**CITY OF BEAUFORT
DESIGN REVIEW BOARD
Staff Report
Meeting of May 12, 2016**

Case Number: 16-04 DRB.3
Project: Tidal Wave Auto Spa
Property Address: 9 Sam's Point Road
Parcel #: R123 015 000 0160 0605 (a portion of this parcel)
Zoning: General Commercial
Design District: Sam's Point Road Design District
Type of Review: **Preliminary Review – New Construction**

LANDSCAPE PLAN

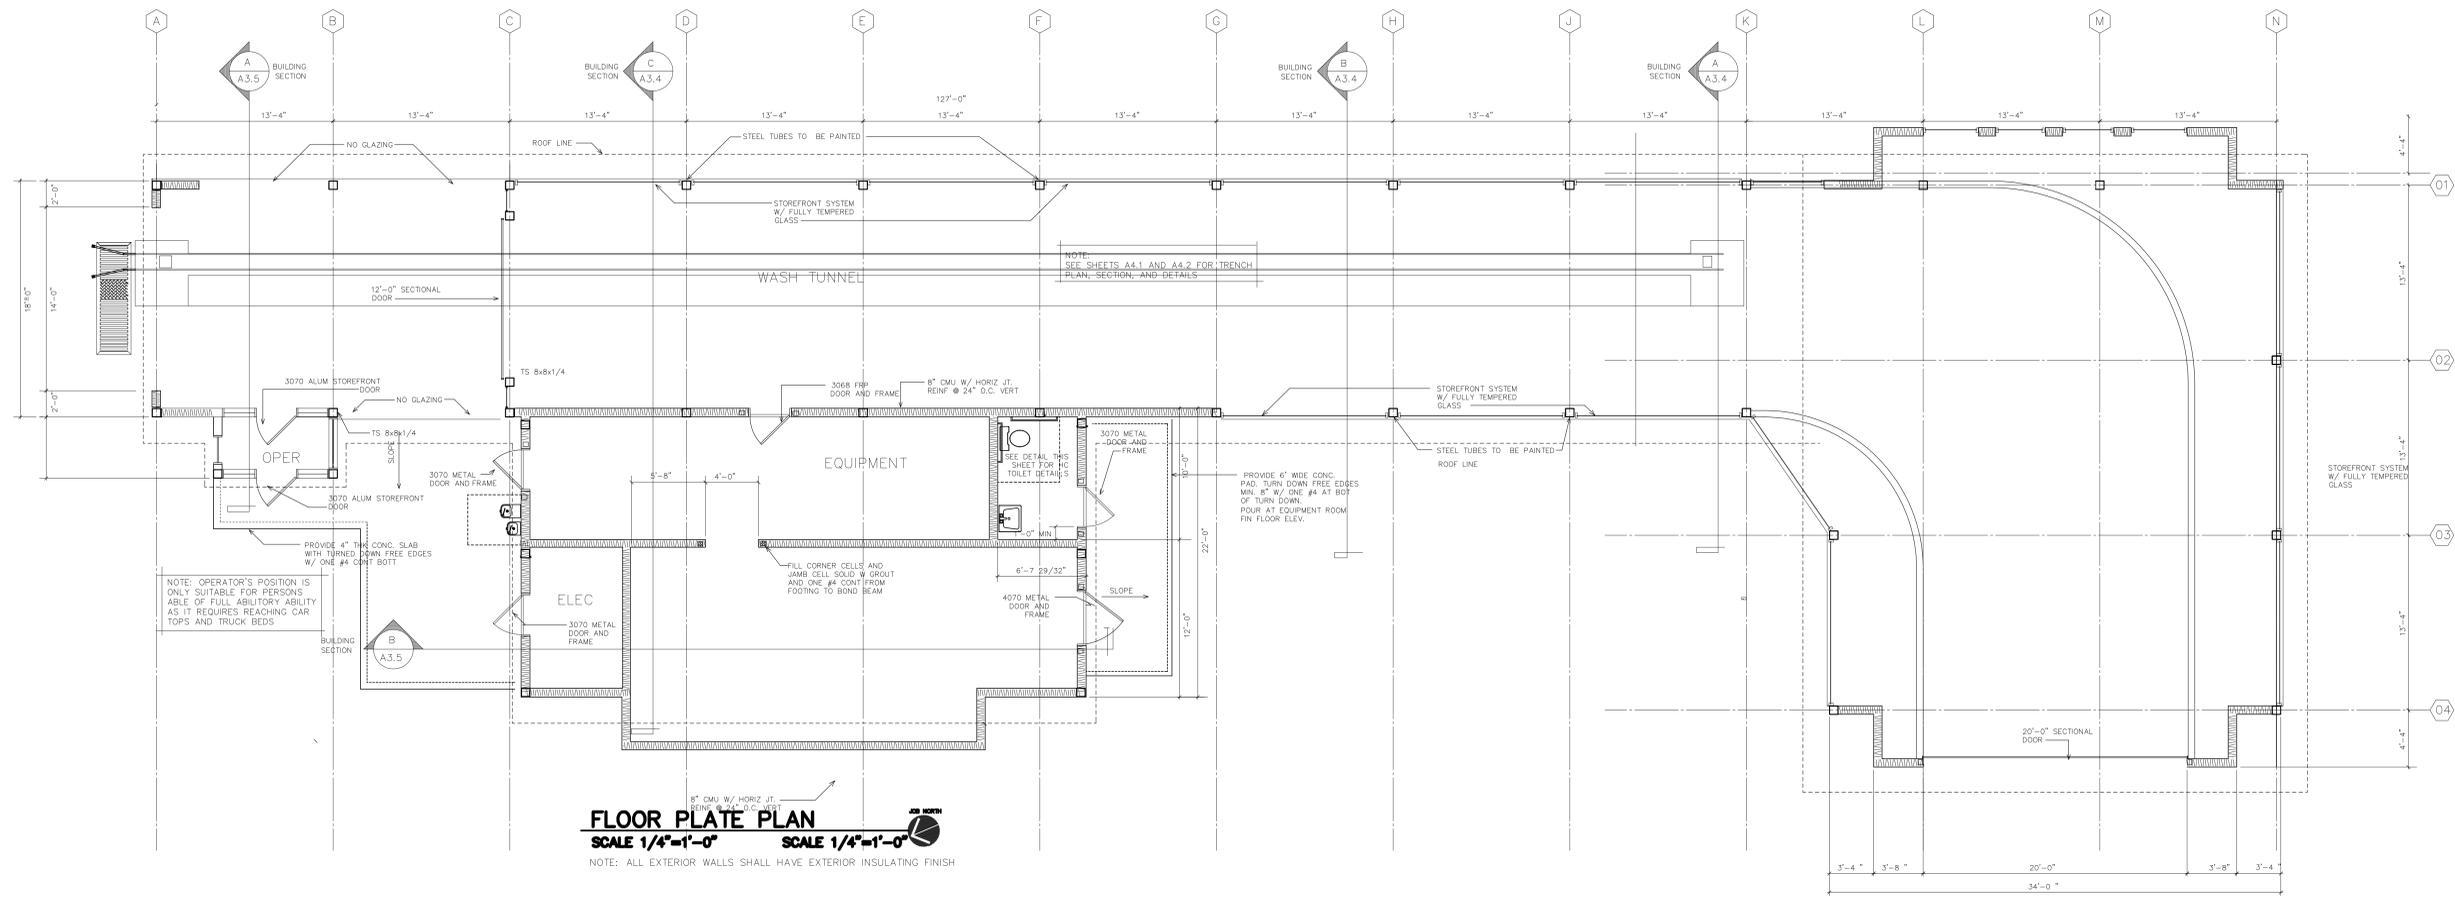
- A lighting plan, showing building and site lighting, will be required. Full-cut off fixtures are required for parking lot lighting.
- Landscaping:
 - Need landscape plan overlaid on tree survey showing both trees to be preserved and removed. Also, trees to be preserved to display tree protection zone at ½' per inch caliper.

- 42" Live oak shown to be preserved displays a canopy radius spread of approximately 20'. A minimum of ¼ of the root protection zone will be impacted by excavation for building, sidewalk and underground tanks. Tree will require root pruning and fertilization a minimum of 3 months prior to site disturbance.

- 26" Laurel oak, rated Category B on Arborists report, located at drive entry should be preserved. Appears to be in area of paving. Request explanation of need for paving at entry point to plant bed. If removal required, 1/3 of caliper inches (9") to be mitigated with broad-leaved overstory trees.

- 50" of grand, Category B trees being removed (2 – 25" Laurel oaks). Request mitigation of 1/3 of caliper inches (17") with broad-leaved overstory trees.

- Section 7.3.E.3.c requires 2 overstory and 4 understory trees per 100 LF in front buffer. Given the build-to line, we can be flexible with this, however it would be more beneficial to plant overstory trees and they would open up visibility to the building.

- Landscape plan shows 5 understory trees proposed for front buffer.
 - Appears there is the potential for preservation of a 24" and 16" Sweetgum (Category B per Arborists report). Retention of these 2 trees fulfills requirement. If applicant prefers, removal of these two trees would be approved but mitigation of 1/3 of the caliper inches of the grand, 24" Sweetgum (8") would be required.

- Suggest planting of 2 or three – 4" caliper overstory hardwood trees (see attached elevation suggestion for tree location) along with proposed understory (note the understory at the southeast corner could be replaced with an overstory).

- Section 7.3.E.3.b requires one broad-leaved overstory tree for every 80 LF in side

buffers. West side buffer requires one; east side requires three. Note: if overstory tree added to front buffer per elevation sketch suggestion, number of trees required for east side buffer decreases to two.

- Landscape plan proposes planting of 4 overstory trees totaling 12 caliper inches. Mitigation, if trees removed as described above in 3, 4 and 5, requires planting of 34 caliper inches. Additional overstory trees required (5), at 3” caliper each added to proposed trees caliper inches totals 27” leaving a shortfall of 7”. Recommend increasing caliper of proposed and required (9) overstory trees to approximately 3.5” in caliper to meet requirement.
